The Commission has issued the enclosed Amendment Nos. 39, 37, 48 and 47 for the Dresden Station Units Nos. 2 and 3 and Quad Cities Station Units Nos. 1 and 2, respectively, in response to your requests of September 10, 1974 and May 17, 1976, as supplemented March 21, 1977 and March 13, 1978.

The amendments revise Technical Specifications to provide operating temperature and pressure limits in accordance with Appendix G, 10 CFR Part 50.

Amendment No. 39
License No. DPR-19

ATTACHMENT TO LICENSE AMENDMENT NO. 39
PROVISIONAL OPERATING LICENSE NO. DPR-19
DOCKET NO. 50-237

Minimum Temperature Requirements per Appendix G of 10 CFR 50

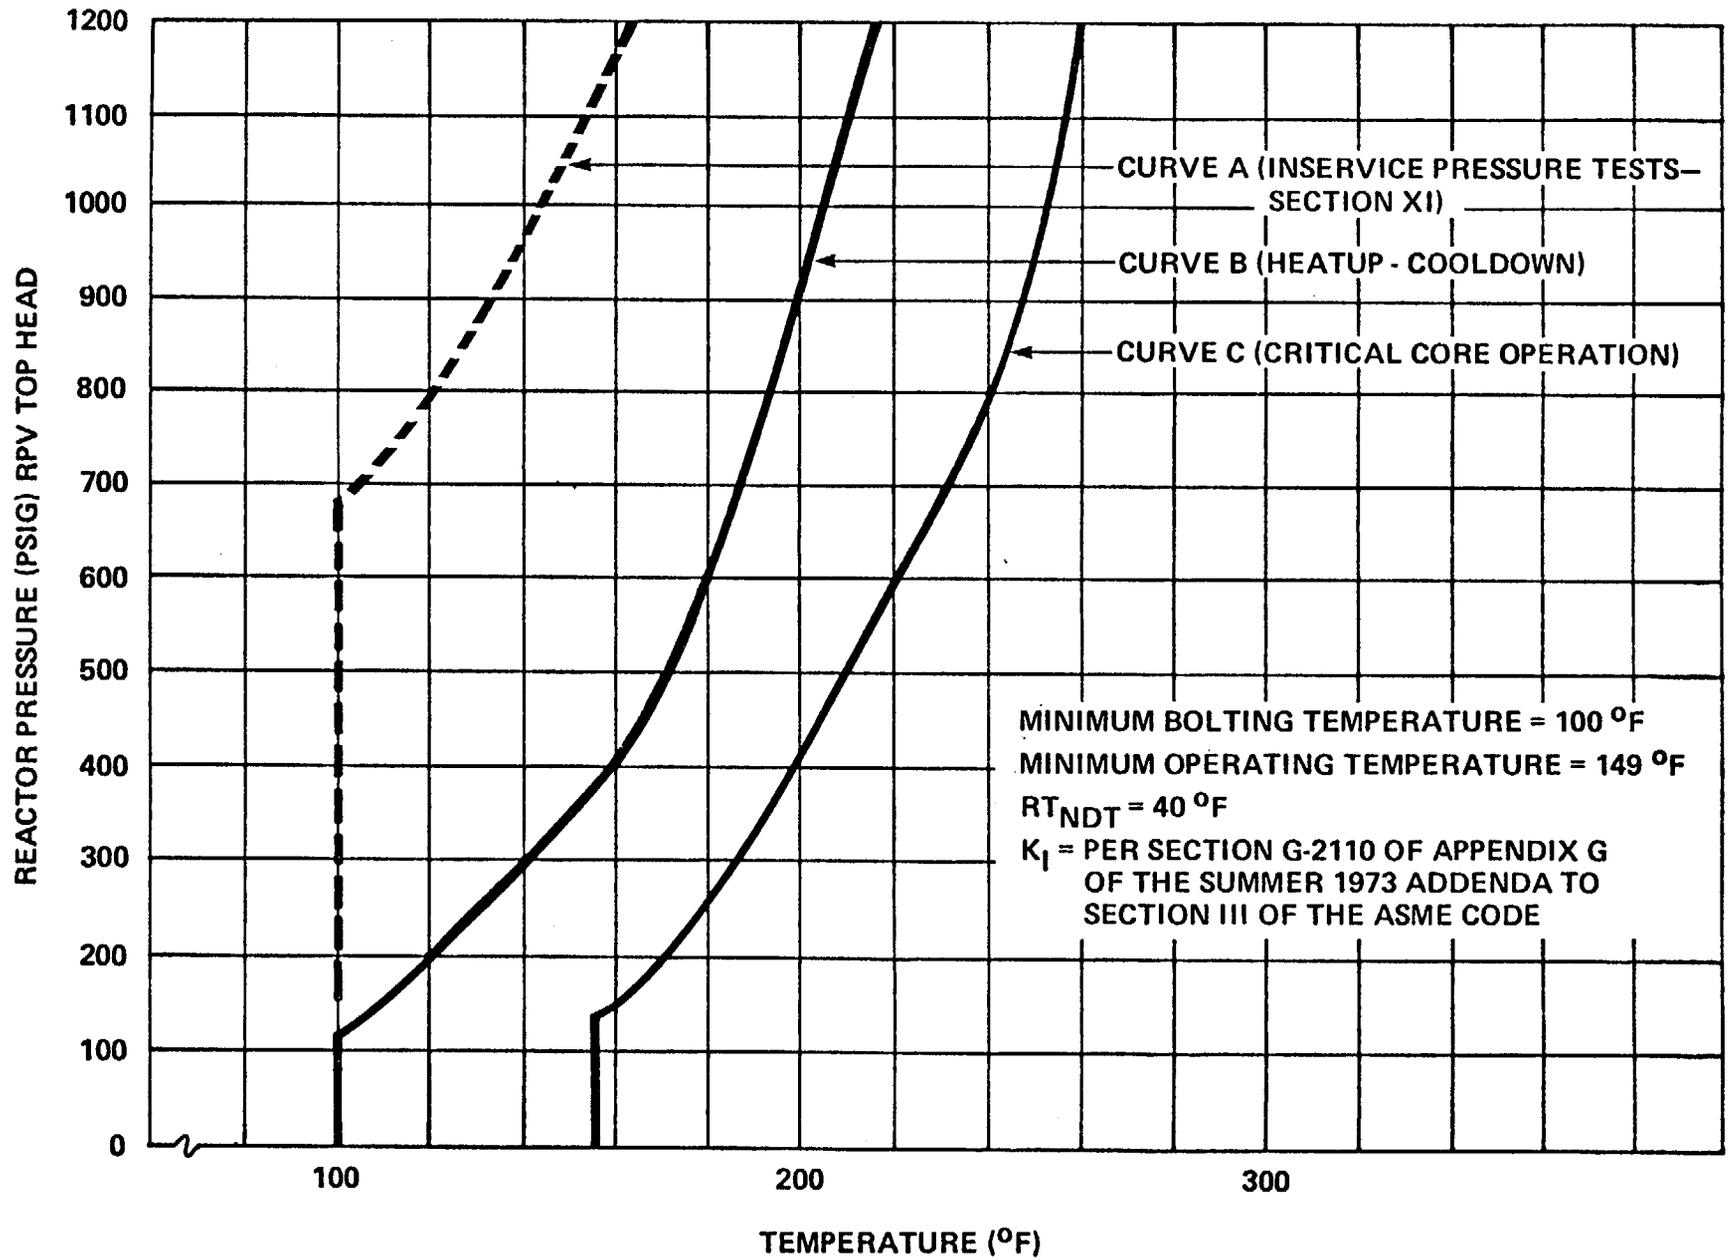
1. The reactor vessel shall be vented and power operation shall not be conducted unless the reactor vessel temperature is equal to or greater than that shown in Curve C of Figure 3.6.1. Operation for hydrostatic or leakage tests, during heatup or cooldown, and with the core critical shall be conducted only when vessel temperature is equal to or above that shown in the appropriate curve of Fig. 3.6.1. Figure 3.6.1 is effective through 6 effective full power years. At least six months prior to 6 effective full power years new curves will be submitted.
2. The reactor vessel head bolting studs shall not be under tension unless the temperature of the vessel shell immediately below the vessel flange is $\geq 100^{\circ}\text{F}$.

Pressurization Temperature - The reactor coolant system is a primary barrier against the release of fission products to the environs. In order to provide assurance that this barrier is maintained at a high degree of integrity, restrictions have been placed on the operating conditions to which it can be subjected. These restrictions on inservice hydrostatic testing, on heatup and cooldown, and on critical core operation shown in Figure 3.6.1, were established to be in conformance with Appendix G to 10 CFR 50.

Minimum Temperature Requirements per Appendix G of 10 CFR 50

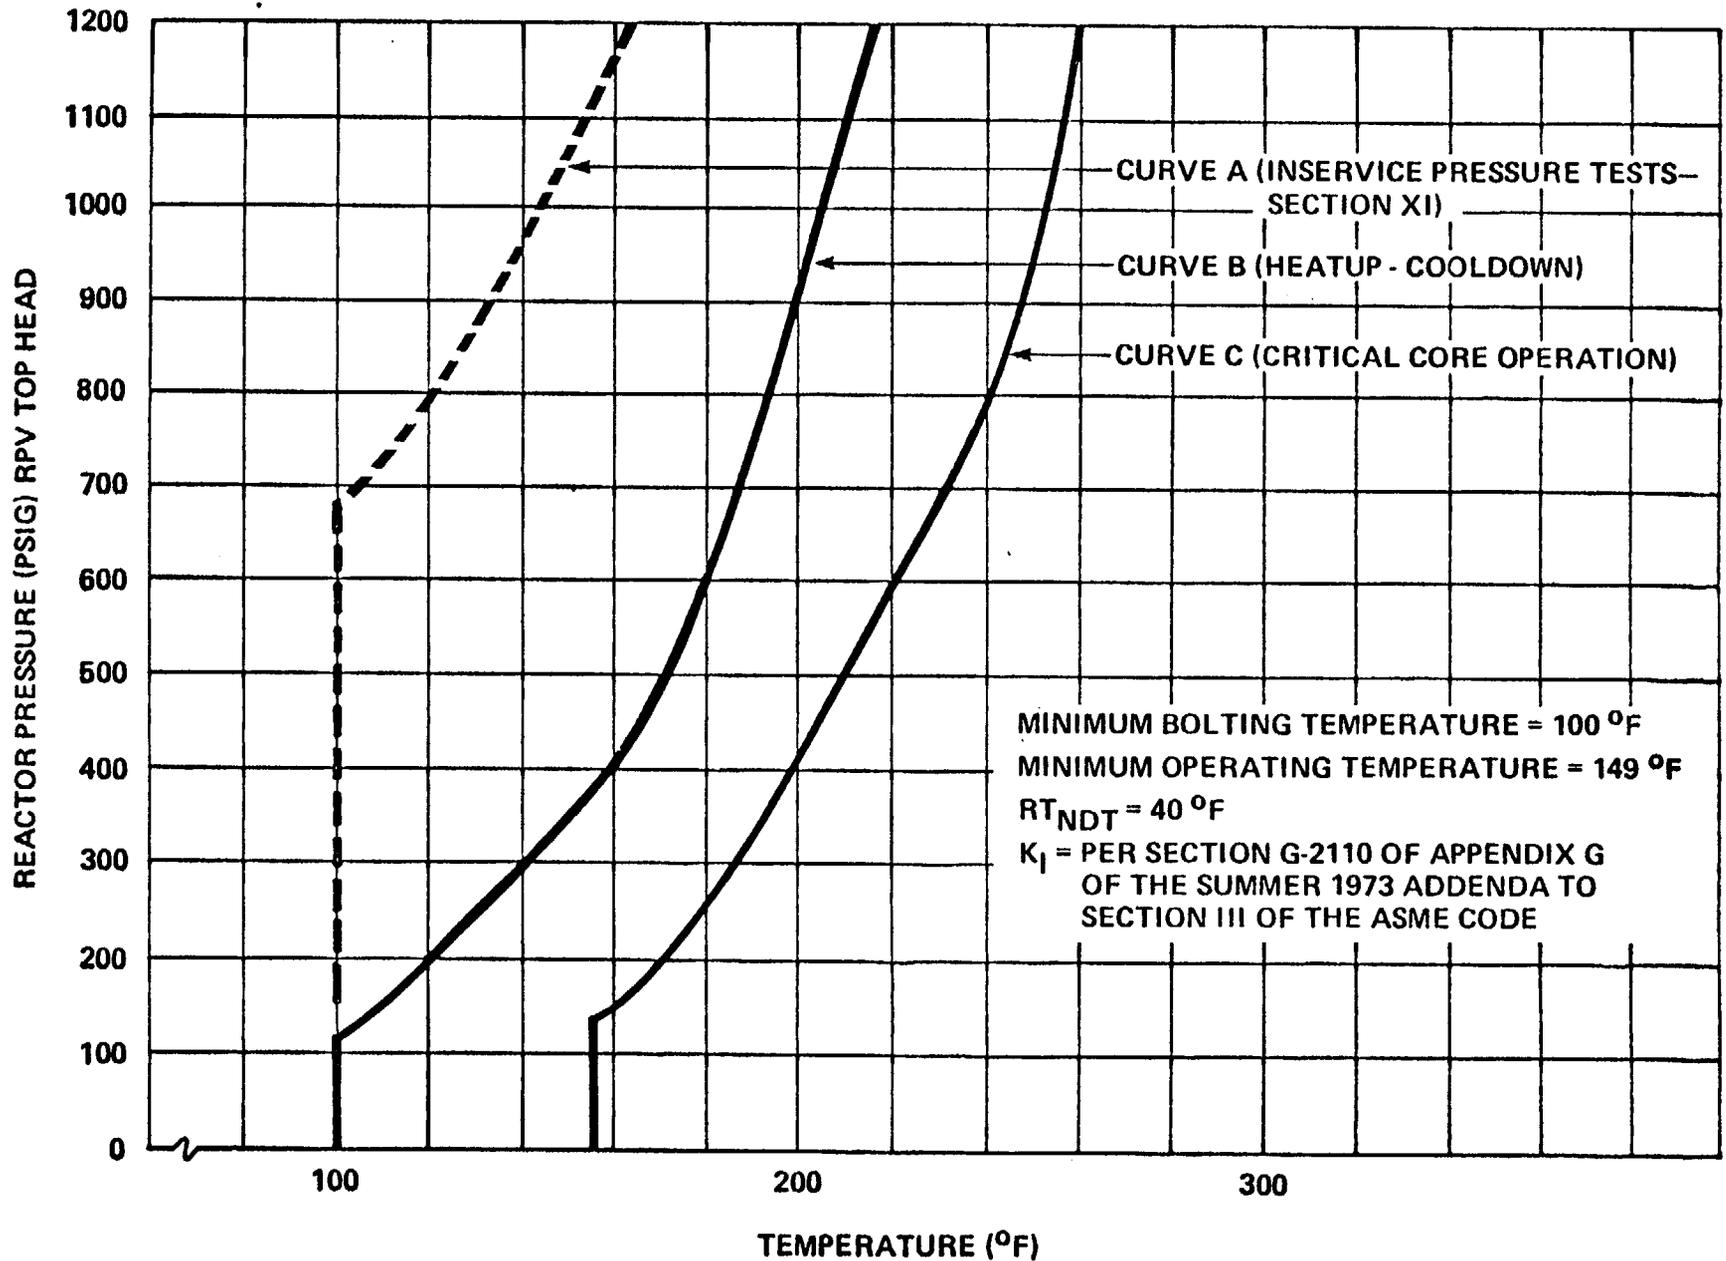
1. The reactor vessel shall be vented and power operation shall not be conducted unless the reactor vessel temperature is equal to or greater than that shown in Curve C of Figure 3.6.1. Operation for hydrostatic or leakage tests, during heatup or cooldown, and with the core critical shall be conducted only when vessel temperature is equal to or above that shown in the appropriate curve of Fig. 3.6.1. Figure 3.6.1 is effective through 6 effective full power years. At least six months prior to 6 effective full power years new curves will be submitted.
2. The reactor vessel head bolting studs shall not be under tension unless the temperature of the vessel shell immediately below the vessel flange is $\geq 100^{\circ}\text{F}$.

Pressurization Temperature - The reactor coolant system is a primary barrier against the release of fission products to the environs. In order to provide assurance that this barrier is maintained at a high degree of integrity, restrictions have been placed on the operating conditions to which it can be subjected. These restrictions on inservice hydrostatic testing, on heatup and cooldown, and on critical core operation shown in Figure 3.6.1, were established to be in conformance with Appendix G to 10 CFR 50.

Fig. 3.6.1

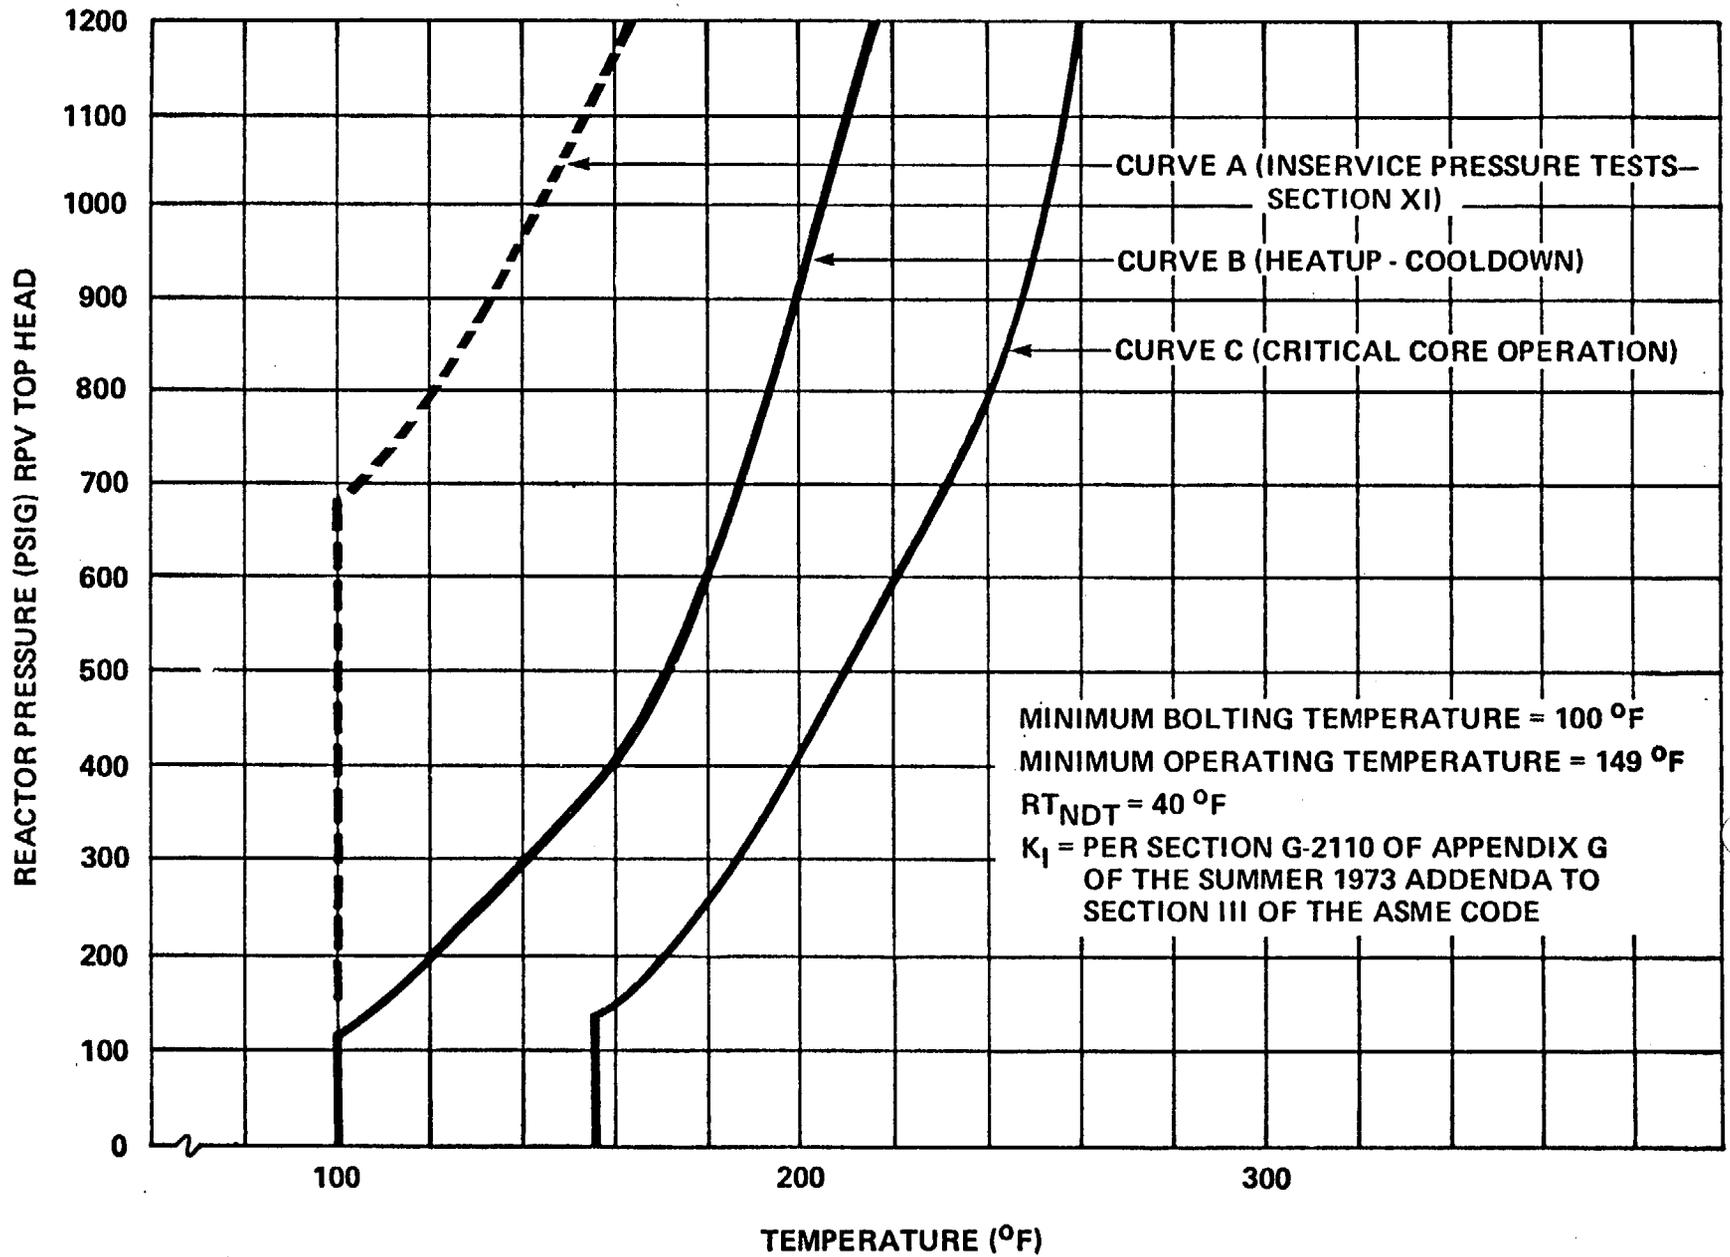
that shown in Figure 3.6-1. Operation for hydrostatic or leakage tests, during heatup or cooldown, and with the core critical shall be conducted only when vessel temperature is equal to or above that shown in the appropriate curve of Fig. 3.6.1. Figure 3.6.1 is effective through 6 EFY. At least six months prior to 6 EFY new curves will be submitted.

The reactor coolant system is a primary barrier against the release of fission products to the environs. In order to provide assurance that this barrier is maintained at a high degree of integrity, restrictions have been placed on the operating conditions to which it can be subjected. These restrictions on inservice hydrostatic testing, on heatup and cooldown, and on critical core operation, shown in Figure 3.6.1, were established to be in conformance with Appendix G to 10CFR50.

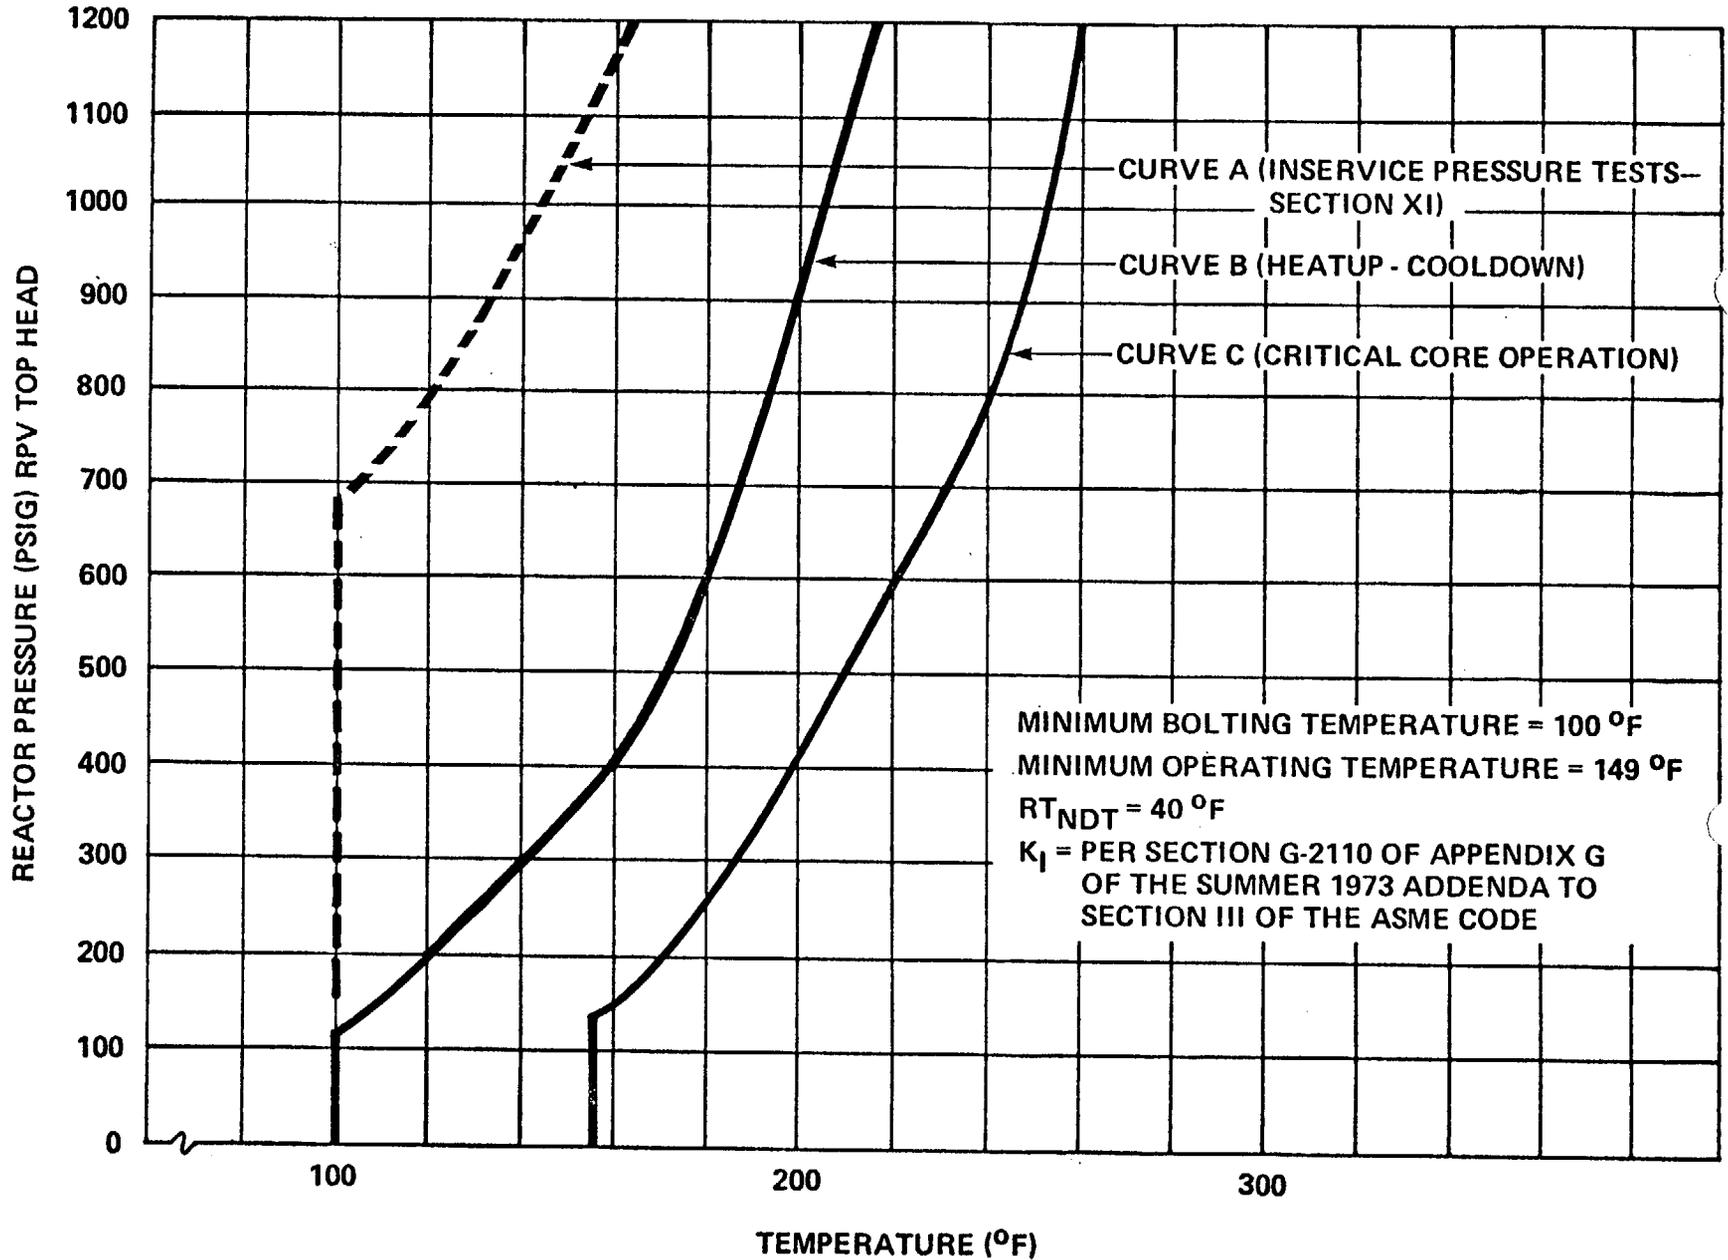
that shown in Figure 3.6-1. Operation for hydrostatic or leakage tests, during heatup or cooldown, and with the core critical shall be conducted only when vessel temperature is equal to or above that shown in the appropriate curve of Fig. 3.6.1. Figure 3.6.1 is effective through 6 EFPY. At least six months prior to 6 EFPY new curves will be submitted.

The reactor coolant system is a primary barrier against the release of fission products to the environs. In order to provide assurance that this barrier is maintained at a high degree of integrity, restrictions have been placed on the operating conditions to which it can be subjected. These restrictions on inservice hydrostatic testing, on heatup and cooldown, and on critical core operation, shown in Figure 3.6.1, were established to be in conformance with Appendix G to 10CFR50.
